Terex Utilities

SAFETY NOTICE

SN-606-13

SUBJECT: Platform leveling arm

Clean and inspect
this area of arm

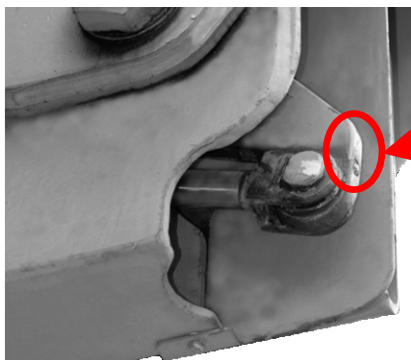
Terex Utilities has received notifications that a structural fatigue crack has been found in some older OM series leveling arms built from 1998 to 2005. The leveling arm keeps the platform level during operation. **Failure of the level arm may result in unintended platform tilting, collision, and occupants falling from the platform.**

This safety notice requires the inspection of the leveling arm, at the elbow, for any cracks specifically in the area indicated below.

1. Clean the area around the grease zerk on each side and visually inspect for cracks. If required use an approved NDT inspection method such as dye penetrant.
2. If a crack is found: Contact Terex Utilities, at the phone number or email shown below and provide the aerial serial number and your contact information to arrange repairs. Remove the machine from service until repairs are completed.
3. If no crack is detected: Contact Terex Utilities; through your nearest TEREX Utilities dealer as shown on the web site, terexutilities.com, call Terex Utilities at 605-884-3892 or by email at utilities.warranty@terex.com to arrange for repair within 30 days of receiving this bulletin.

Machines affected by this safety notice may remain in service provided the leveling arm is inspected, for cracks, before and after each working shift until this safety notice is completed.
